A d d e n d u m

Iowa Department of Transportation
Office of Contracts

B.O.	Proposal ID	Proposal Work Type	County	Project Number	Addendum
011	57-1001-105	BRIDGE NEW - PPCB	LINN	NHSX-100-1(93)--3H-57 NHSX-100-1(94)--3H-57 NHSX-100-1(95)--3H-57 NHSX-100-1(96)--3H-57 NHSX-100-1(97)--3H-57 NHSX-100-1(98)--3H-57 NHSX-100-1(104)--3H-57 NHSX-100-1(105)--3H-57 NHSX-100-1(108)--3H-57	17MAY011.A03

Make the following changes to the NHSX-100-1(95)--3H-57 plans:

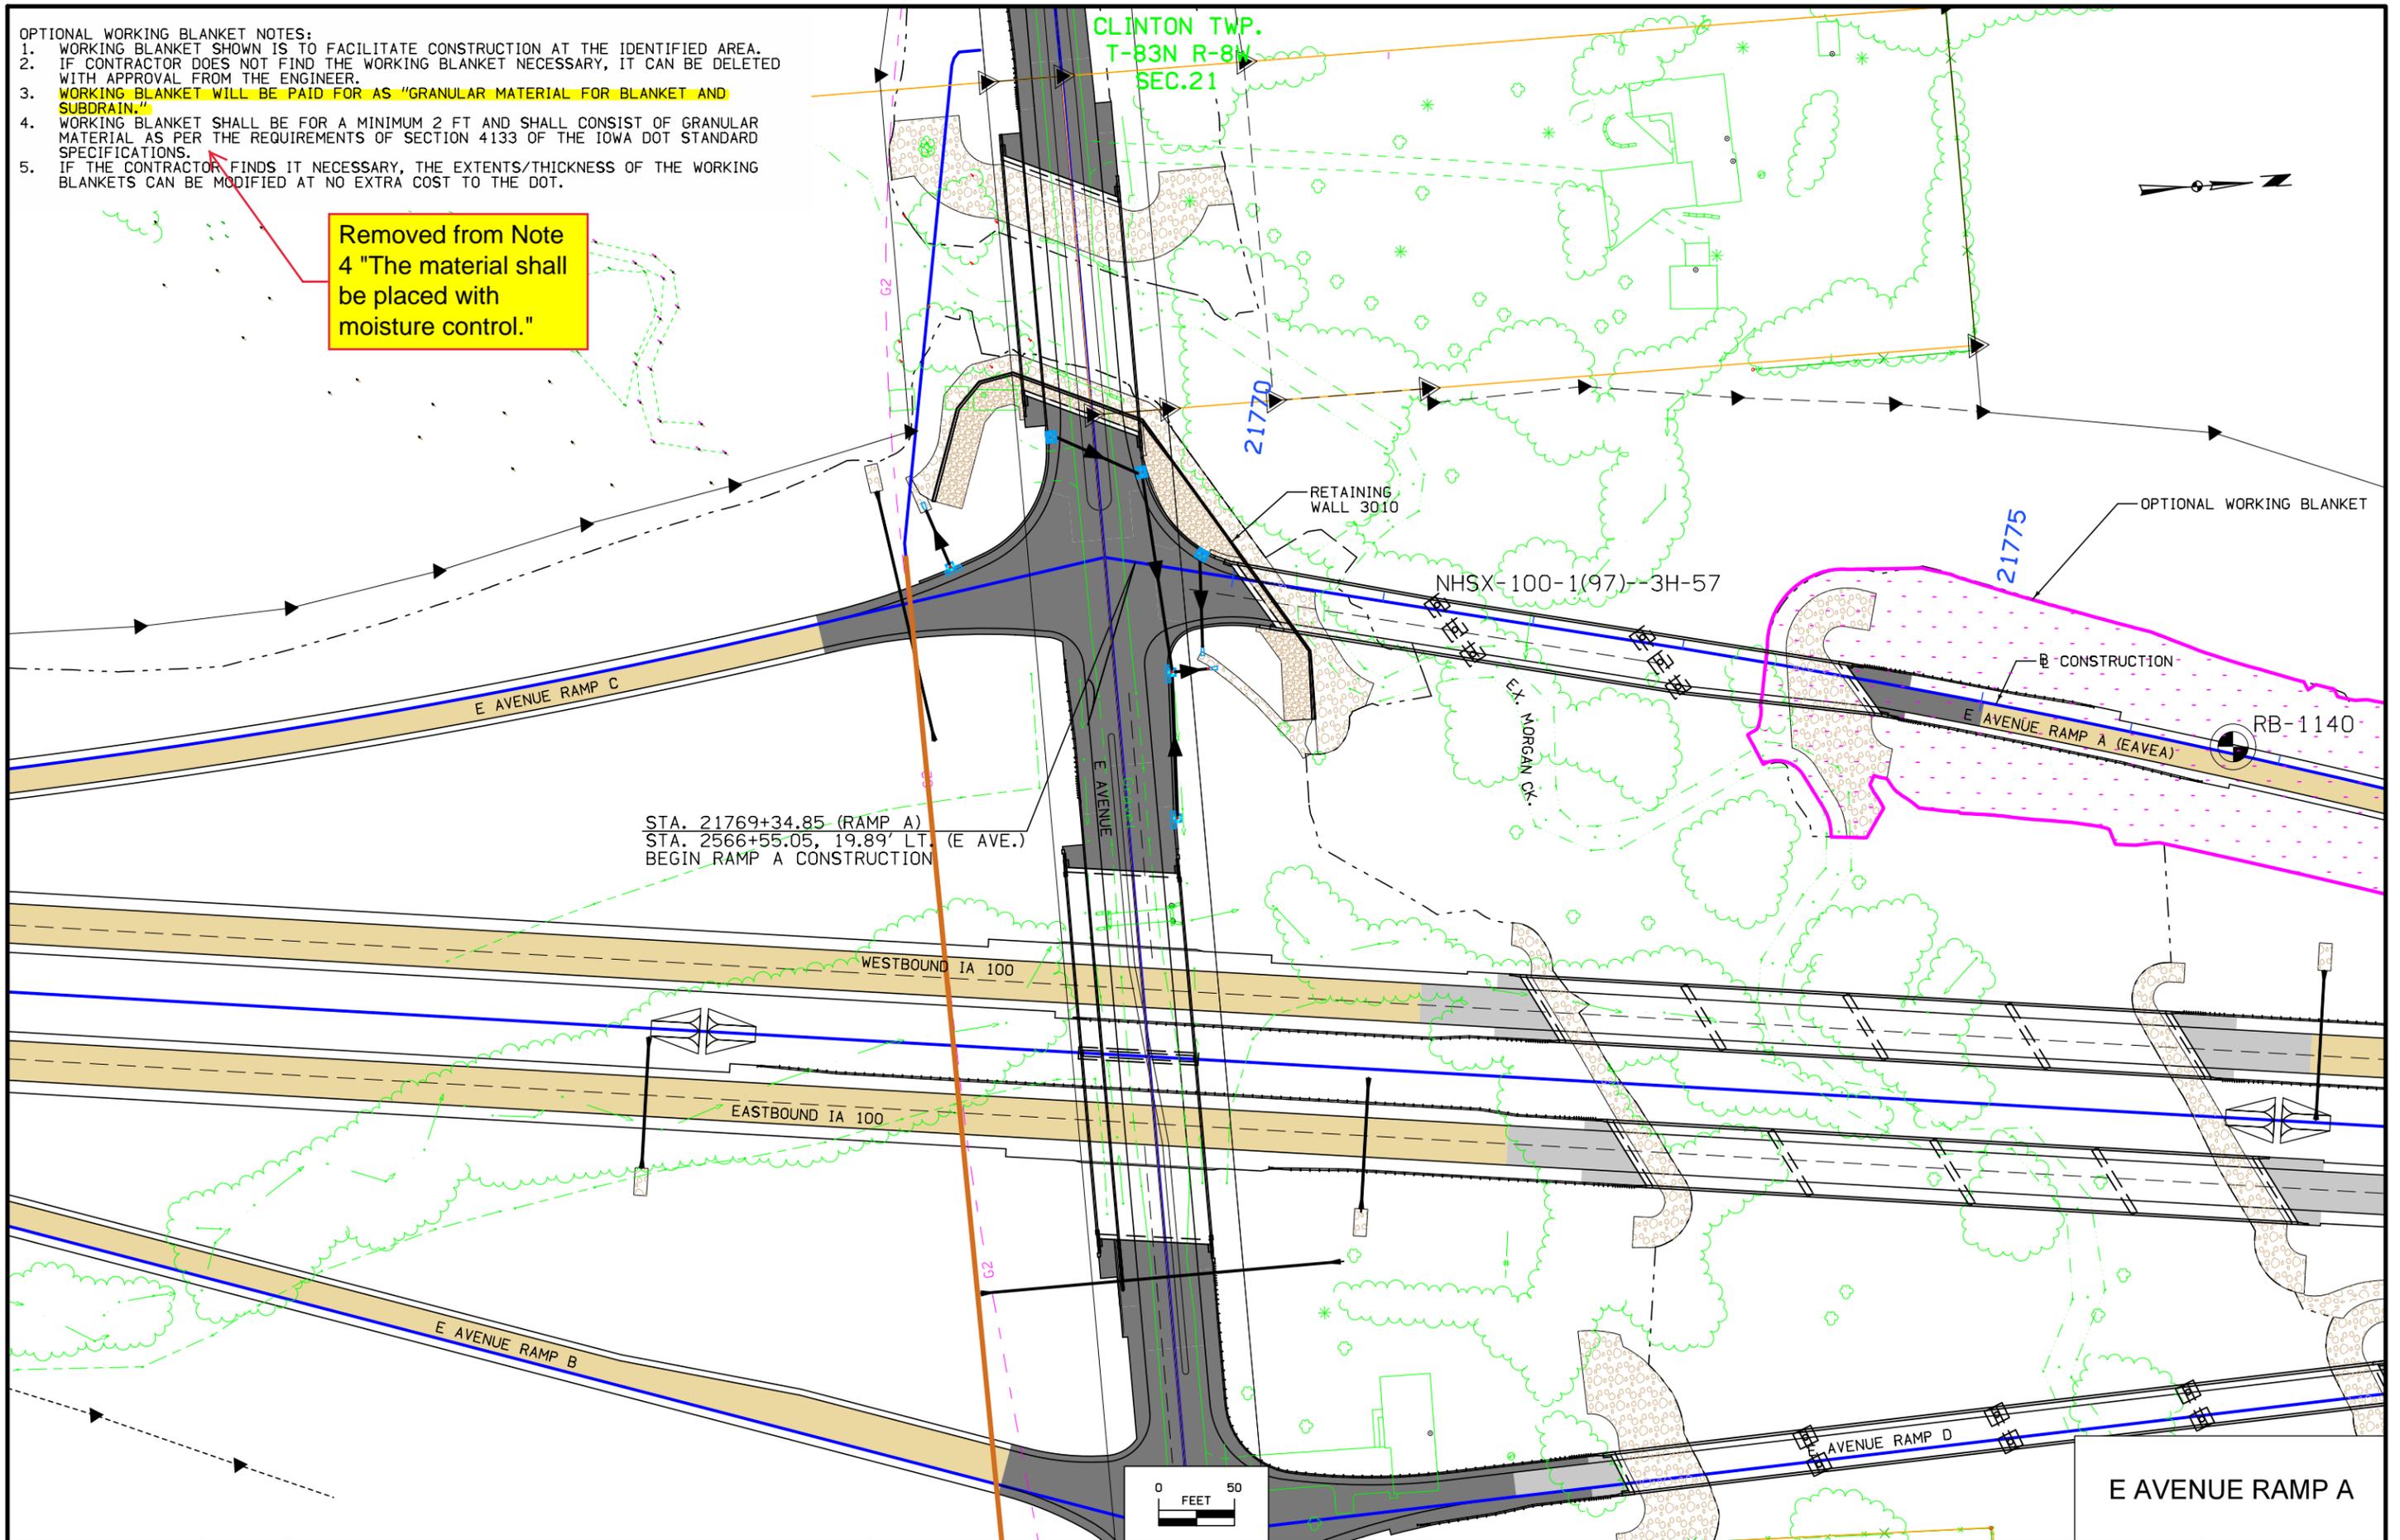
Removed from Note 4 "The material shall be placed with moisture control."

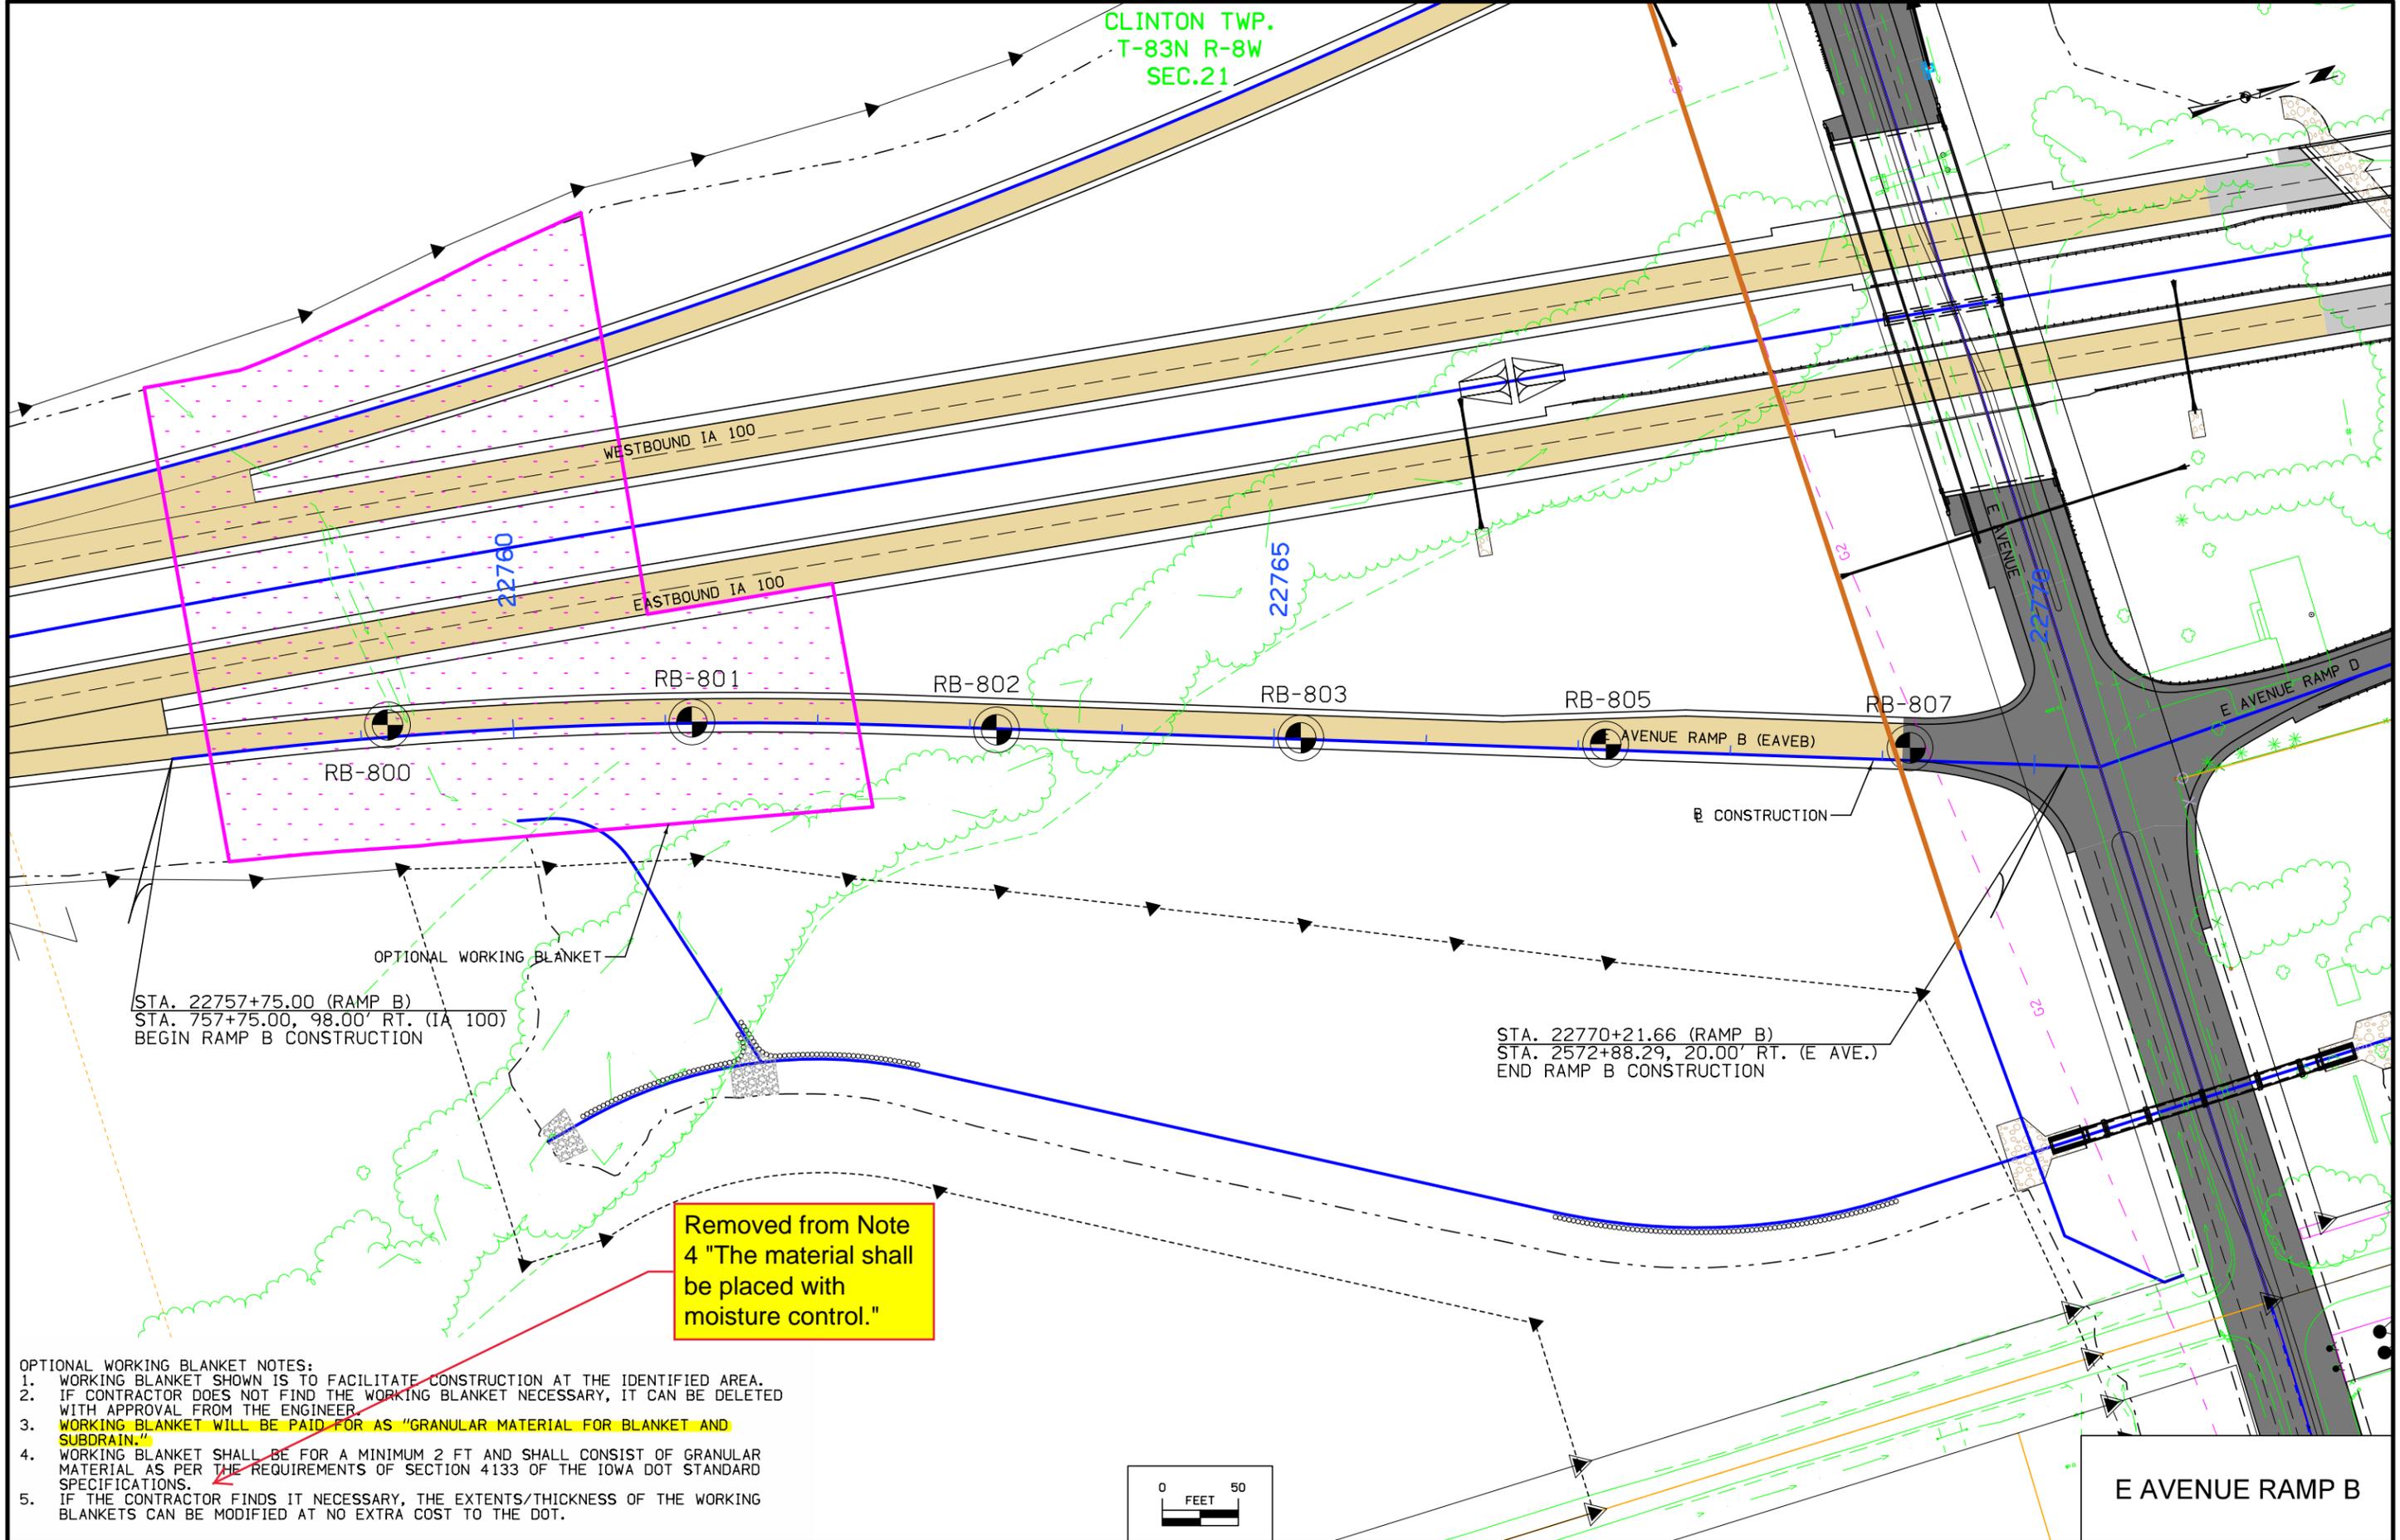
Removed from Note 4 "The material shall be placed with moisture control."

FILE NO.	ENGLISH	DESIGN TEAM	Iowa DOT/CH2MHILL	LINN COUNTY	PROJECT NUMBER	NHSX-100-1(105)--3H-57	SHEET NUMBER	Q.47
----------	---------	-------------	-------------------	-------------	----------------	------------------------	--------------	------

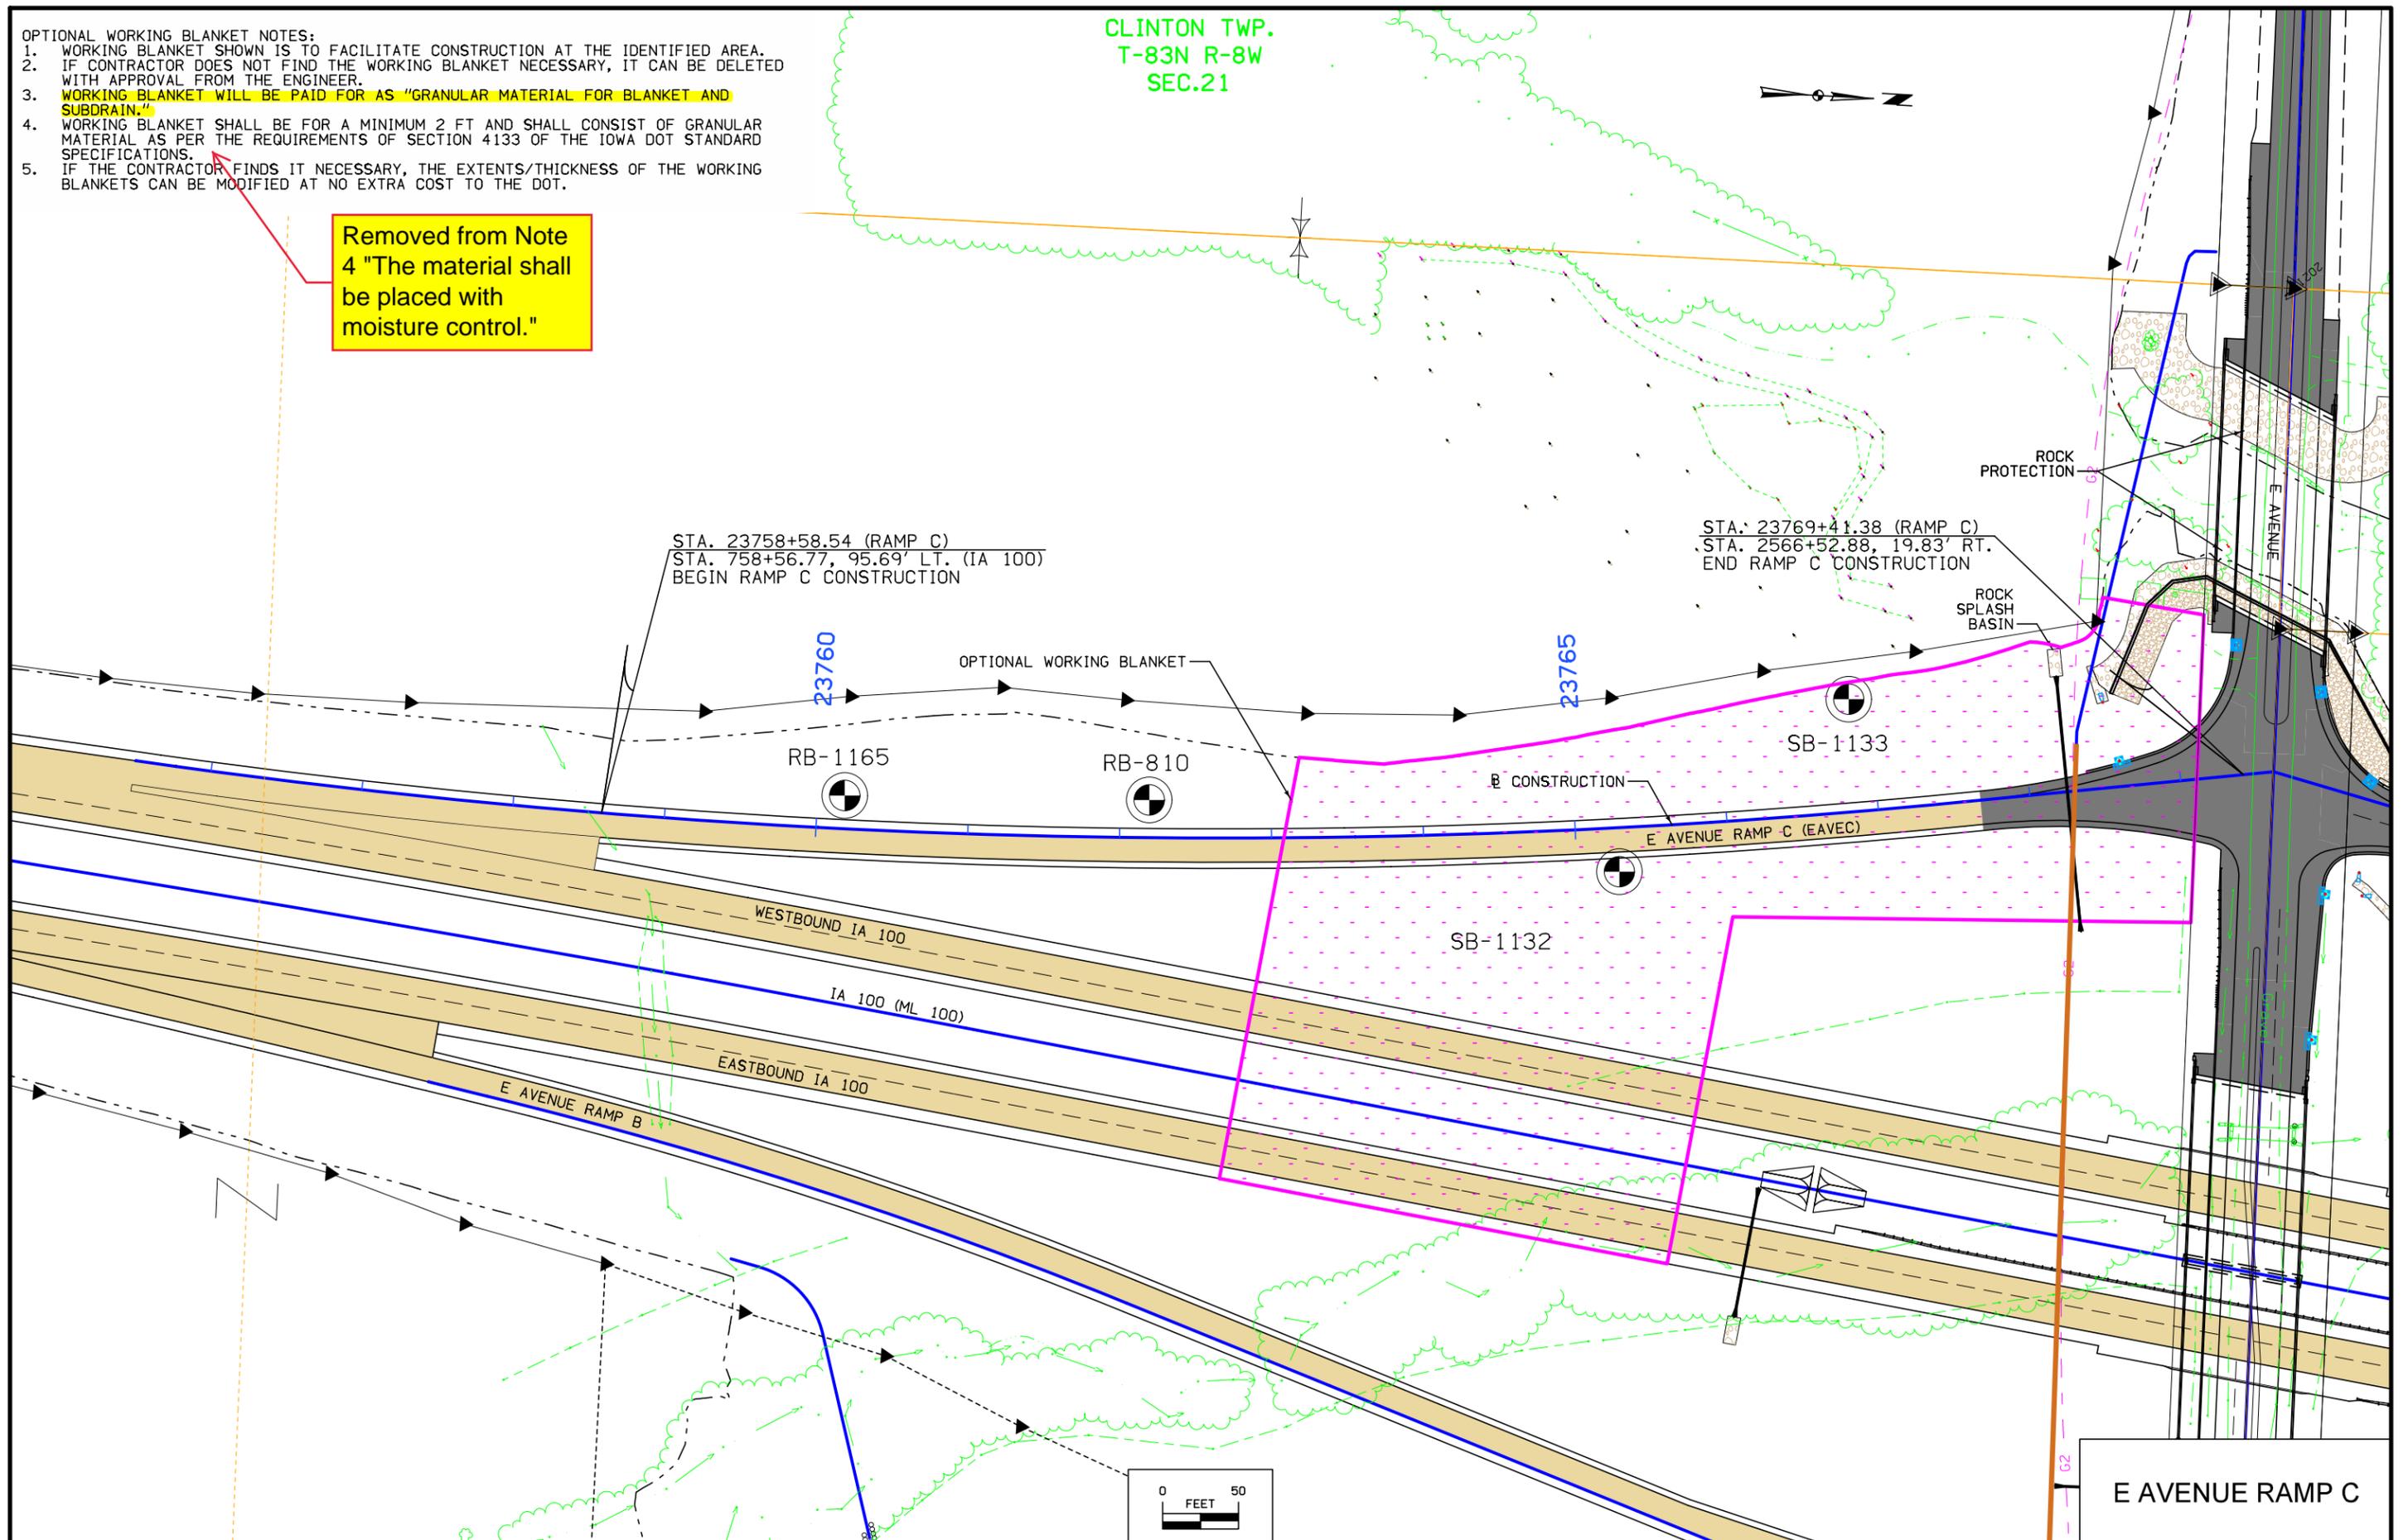
Removed from Note 4 "The material shall be placed with moisture control."
